Access Compliance Report Public Rights-of-Way (Pedestrian Signals)

Main Street: **EL CAMINO_LN** Cross Street: **NEWPORT_AVE** Location: **SW**

ADA ID: **SGRK211007132159** Signal Type: **One Push Button-Non APS** Overall Compliance: **No** Severity Scores: **BTN 1: 25** **BTN 2: N/A** **No BTN: N/A**

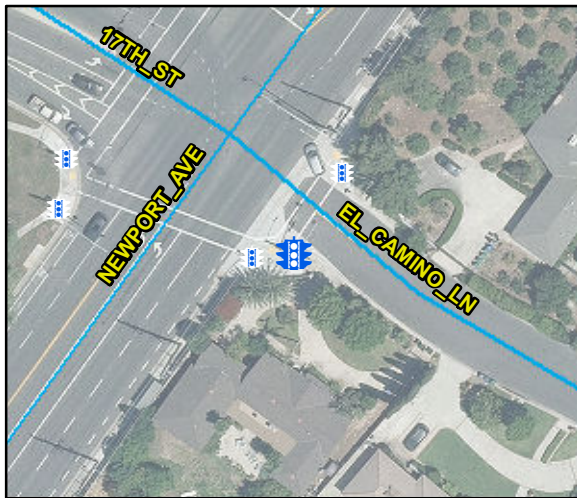
Possible Solutions: Remove and Replace Clear Space.

OC Std/PROW: **R404.2**
